Memorandum

To: Jim Totten, General Manager
Lost Pines Groundwater Conservation District

Subject: Review of City of Bastrop Operating Permit Application Packet

Figure 2. Location of the proposed City of Bastrop wells and nearby Simsboro wells.

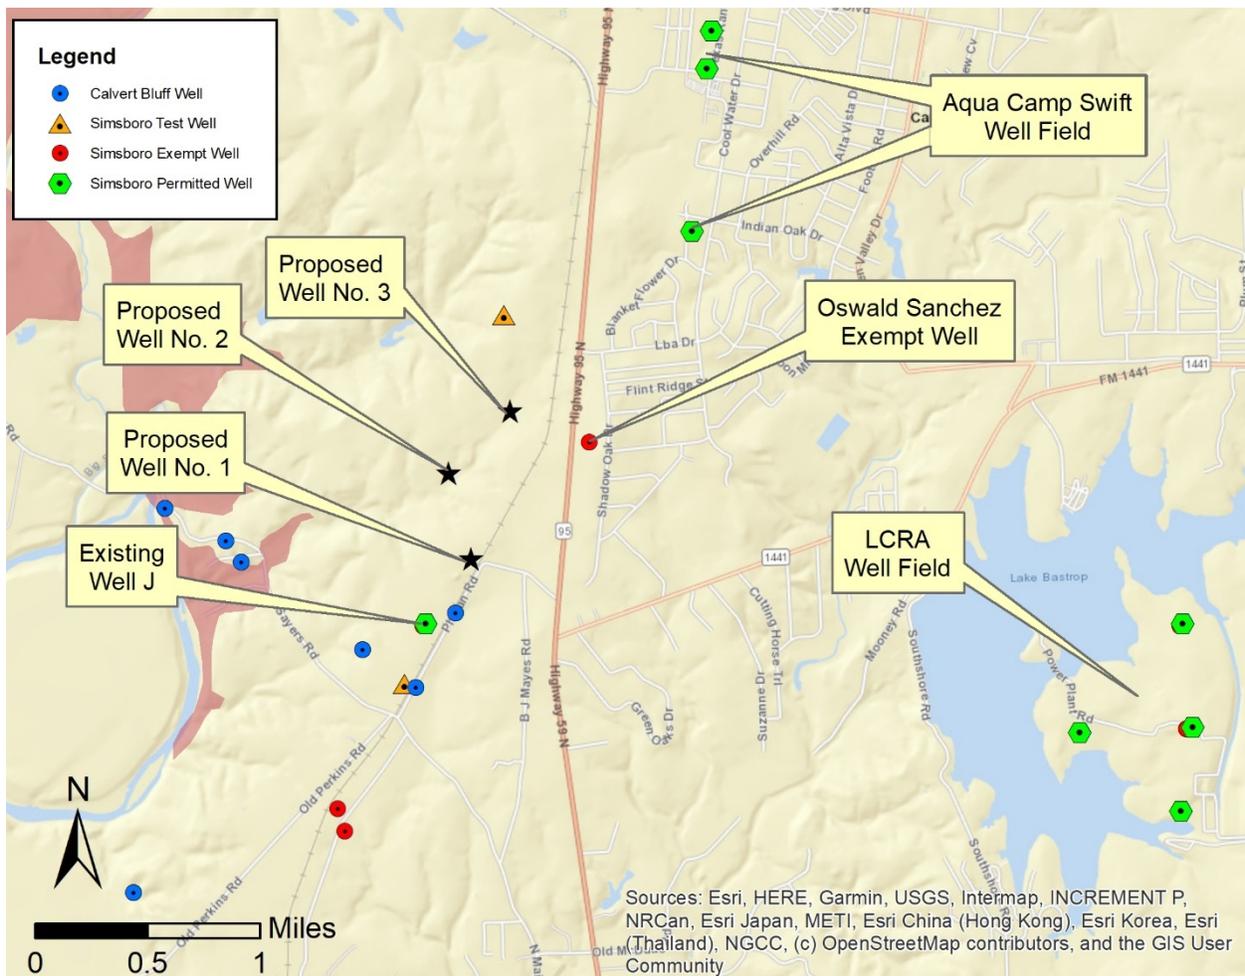
As shown in Figure 2, the location of the proposed well field is just to the southwest of the existing Aqua Camp Swift well field, which produces water from the Simsboro Aquifer. The closest of the proposed City wells is slightly more than one mile from the Aqua CS-5 well. The proposed City well field is also approximately 2 miles west of the LCRA well field near Lake Bastrop. In addition to these permitted wells, the proposed wells are as close as approximately 2,000 feet from an exempt well owned by Oswald Sanchez that produces from the Simsboro Aquifer (Figure 2). However, the City included a variance letter from Mr. Sanchez in their permit applications indicating that he is not opposed to the proposed City wells.

Figure 3. Fifty-year drawdown (in feet) in the Simsboro Aquifer attributable to the proposed City of Bastrop pumpage

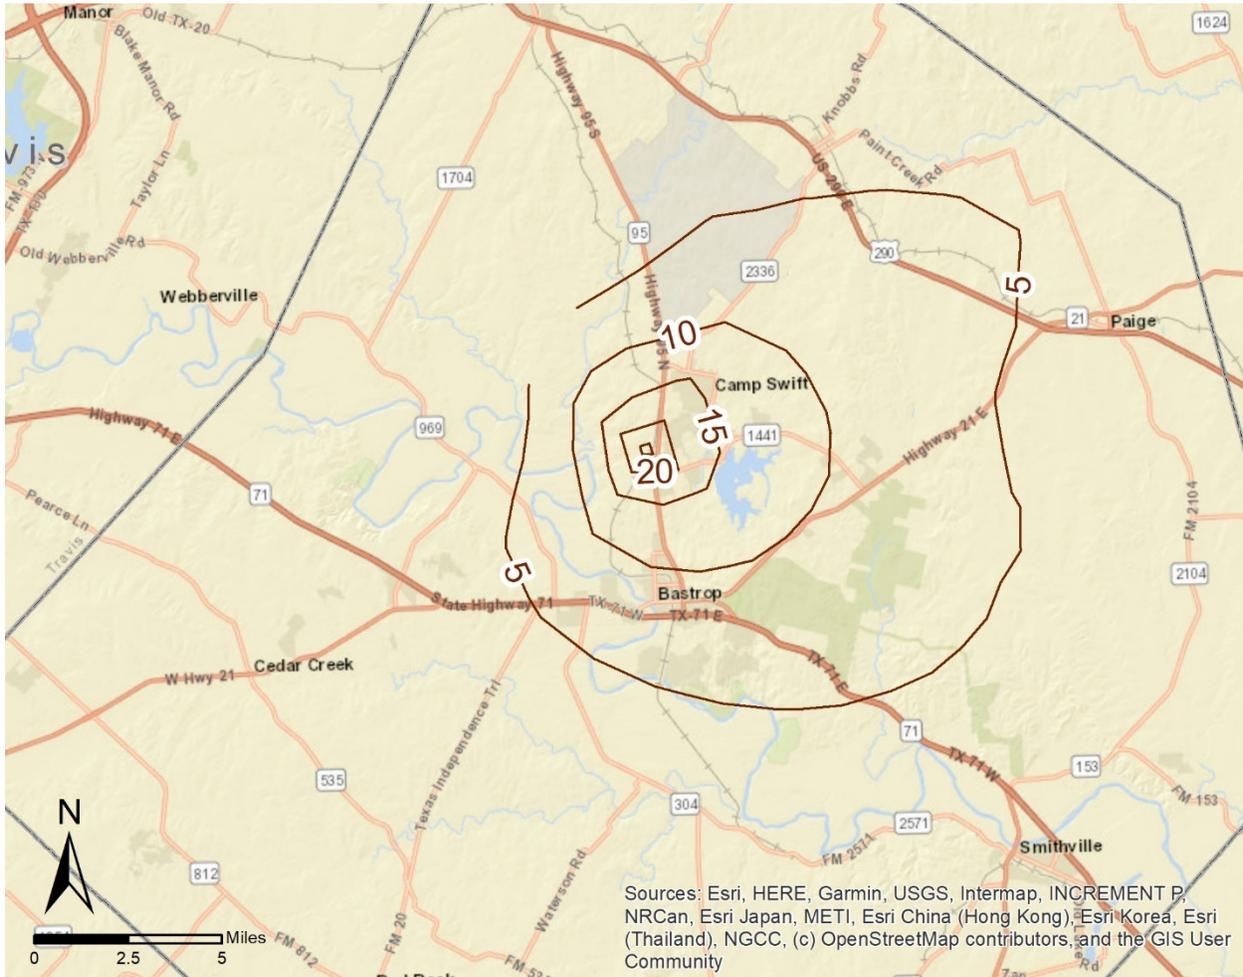
The updated Central Queen City-Sparta Groundwater Availability Model (GAM) was run with the proposed pumping of 4,000 acre-feet per year (ac-ft/yr) added in the nodes where the proposed wells are located. The results of this simulation are provided in Figure 3, which illustrates that at

the end of 50 years of continuous pumping, the project-specific drawdown attributable to the three new proposed wells (i.e., drawdown caused by the pumping from the proposed wells only) is approximately 25 feet at the well field location. The model run also indicates that the Aqua Camp Swift wells may experience 15 to 20 feet of drawdown due to the pumping from the three proposed City of Bastrop wells, and that the LCRA wells may experience 10 to 15 feet of drawdown due to the proposed City pumpage.

It is important to understand that the predicted water level declines are estimates made using the GAM, which was developed to assess groundwater impacts on a regional basis and may not account for local hydrogeologic conditions. A review of the aquifer properties of the Simsboro Aquifer in the XS Ranch well field area indicates that the GAM includes aquifer transmissivities that are 50 to 100 percent higher than those estimated based on aquifer tests included with the City of Bastrop applications. Aquifer storativity values in the GAM are consistent with those calculated from the pumping tests. The higher transmissivities in the GAM will result in lower predicted drawdowns in the vicinity of the well field relative to those that may occur in reality. However, it is reasonable to assume that the pumping from the three proposed City of Bastrop wells would result in several tens of feet of drawdown in the Aqua Camp Swift well field, and slightly less in the LCRA well field area.

The proposed additional production of 4,000 ac-ft/yr by the City from the three proposed wells in Bastrop County will impact water levels in the Simsboro Aquifer. Drawdowns for the entire Lost Pines GCD estimated using the GAM are summarized in Table 1. As indicated in the table, the average drawdown estimated to occur due to the proposed well field is approximately 7 feet across the entire District. A map of project-specific drawdowns

estimated using the GAM is shown in Figure 3. This proposed project does not appear to unreasonably impact groundwater users in the District.
